ATTENTION!

PLK DESIGN 2 (6) replaces PLK DESIGN 1 (5) and most PLK DESIGN 1 (5) C-numbers
Where applicable, PLK DESIGN 1 (5) and C-numbers have been automatically converted

PLK DESIGN 2 (6)

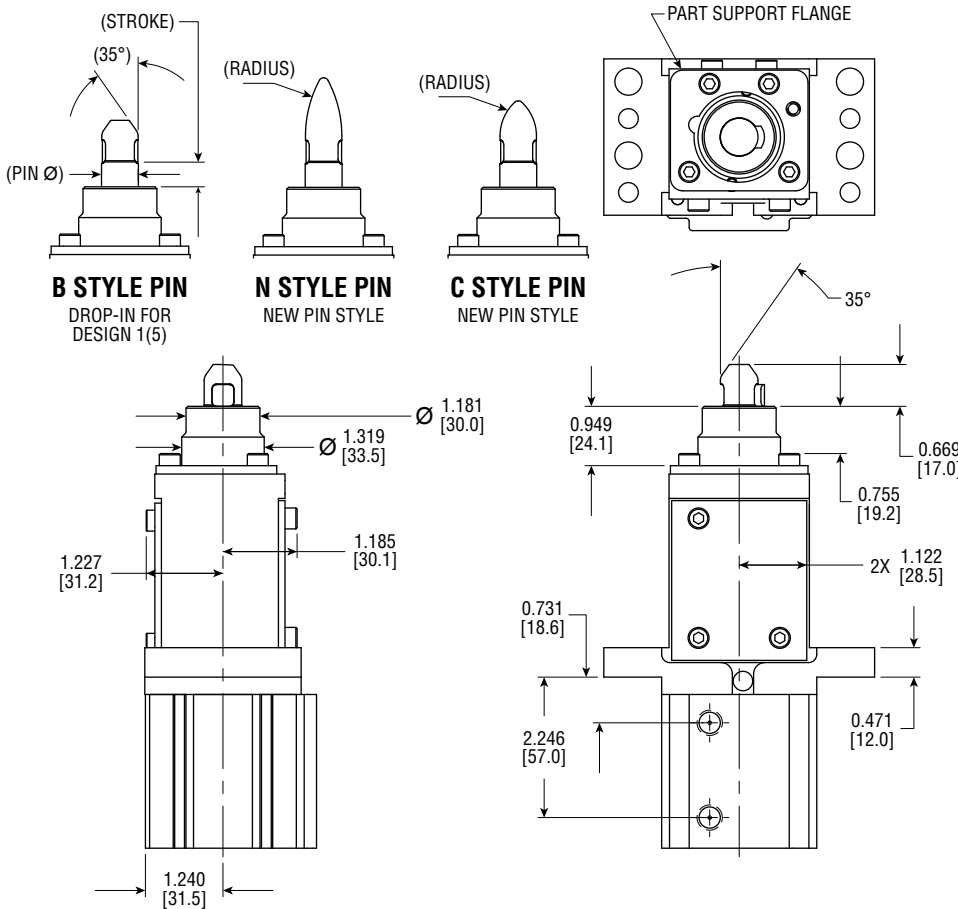
PIN Ø = PIN Ø SPECIFIED = +0.00 / -0.02 mm
 (+0.0000 / -0.0008 in)

PIN Ø AVAILABLE FROM 12.00 mm TO 30.00 mm

- 2 strokes (505 & 510)
- Imperial (2) & Metric (6) Ports
- 1800 pin diameters 12.00 thru 30.00 (+.00/- .02 mm Tolerance)
- 3 Pin Styles (B, C & N)
- Std. Flange Mount Height (110 mm to 140 mm - .5 mm increments)
- 4 Std. Finger Directions (Easily changed in the field)
- Standard Single Finger and Dual Finger (15 mm dia and above)
- Port Position 1 thru 4 (available with all positional sensing options)
- Port Fittings (-LAA & LBB)
- Cylinder Options (-R01 & R02)
- Cylinder Switch options (SW00, 41, 42, 51 & 52)
- Additional Rear Mounting options standard (-B01 thru -B06)
- Lock Setting (-MT00 thru -MT40) (See page 2 for new lock adjustment procedures)

Previous PLK DESIGN 1 (5) and associated C-numbers are only available as Unique Solutions®.
